TOWN OF MONTVILLE
Department of Land Use & Development
Staff Comments and Technical Review
Prepared by Meredith Badalucca on July 21, 2025

Property Address: 257 Chesterfield Road (029-066-000)
Application: 25 SUB 4
Property Owner: Zachary Cash
Applicant: Michael Desautels
Land Surveyor: Brian Florek, LS CFS
P.E.: Joseph Wren, PE
Lot Size: 60 +/- Acres
Zoning District: R-80 (Residential)
Public Water/Sewer: Individual wells and Municipal Sewer
Flood Hazard Zone: Portion within 0.2 annual chance flood hazard zone
CAM Zone: No
Public Water Supply Watershed: No.
Bond Estimate: \$9,500
Legal: Submitted to Land Use Dept. on 6/23/25. Date of Receipt by PZC 6/24/25, Public Hearing scheduled for 7/22/25. Notice of Public Hearing will be published in The Day on 7/9/25 and 7/16/25.
Site Inspection: Site visit completed on 6/25/25 by ZEO Radford, Kyle Haubert, Town Engineer, and myself. See attached inspection report completed by ZEO Radford.

Proposal: 4 lot resubdivision with a 10.47 acre area to be combined with 237 Chesterfield Road.

RE: 25SUB4 - Desautel's Resubdivision
257 Chesterfield Road, Montville, Connecticut
CLA-7873M

Approx area of
proposed culert

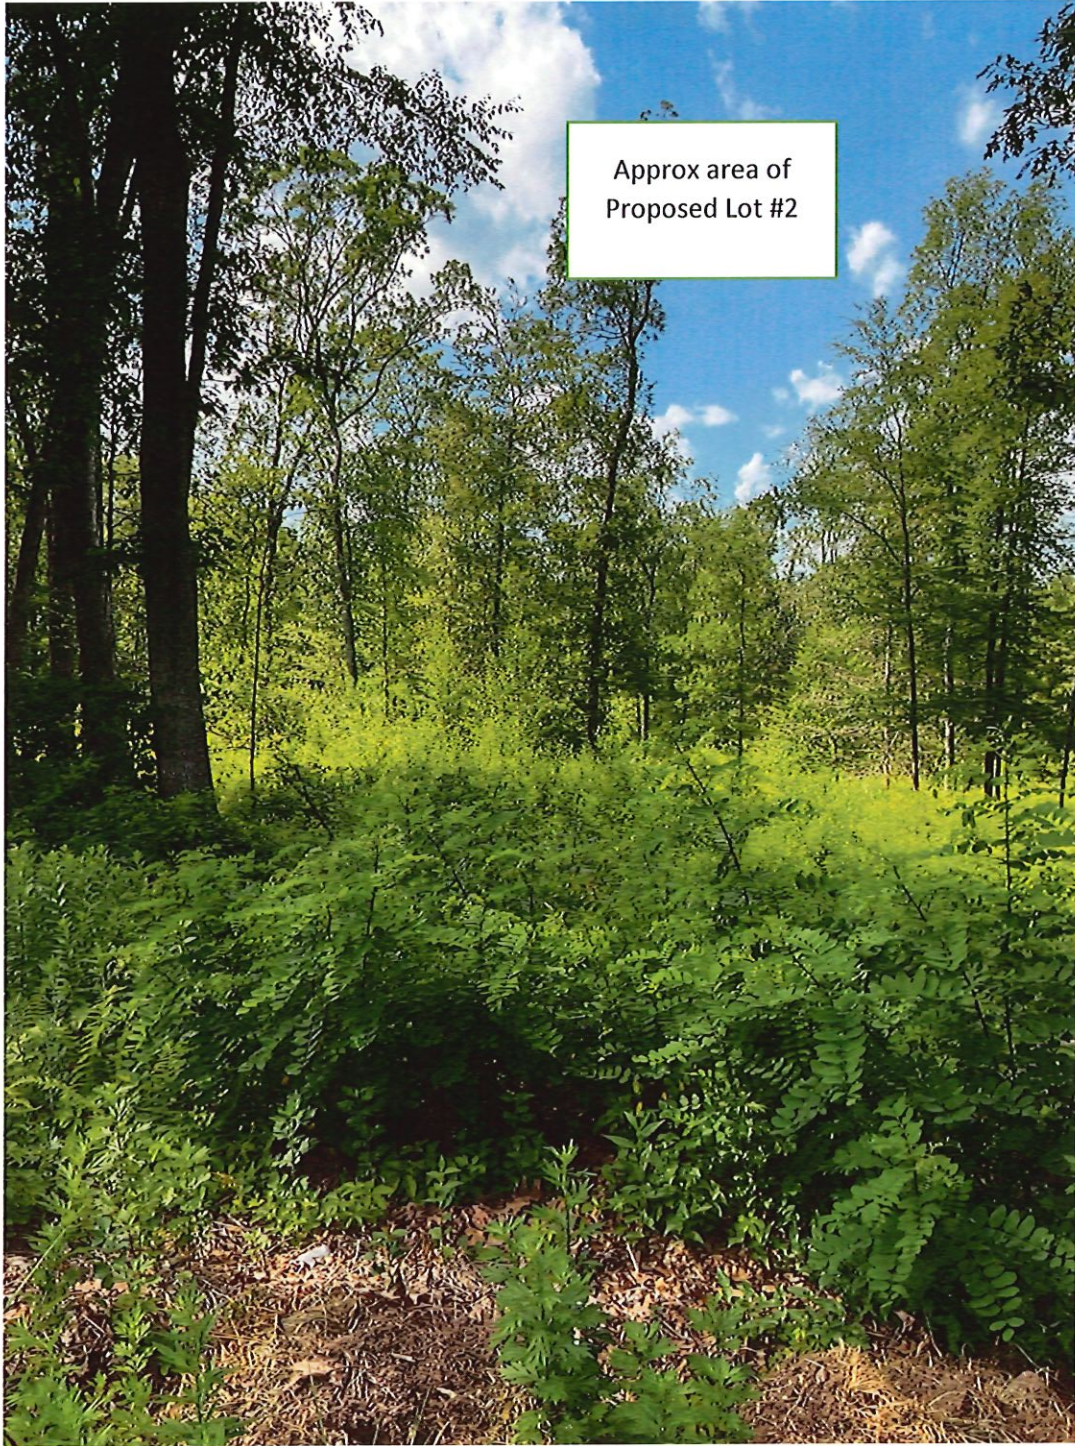
Completed an inspection of property which is subject to a PZC Application for a 4-lot resubdivision.
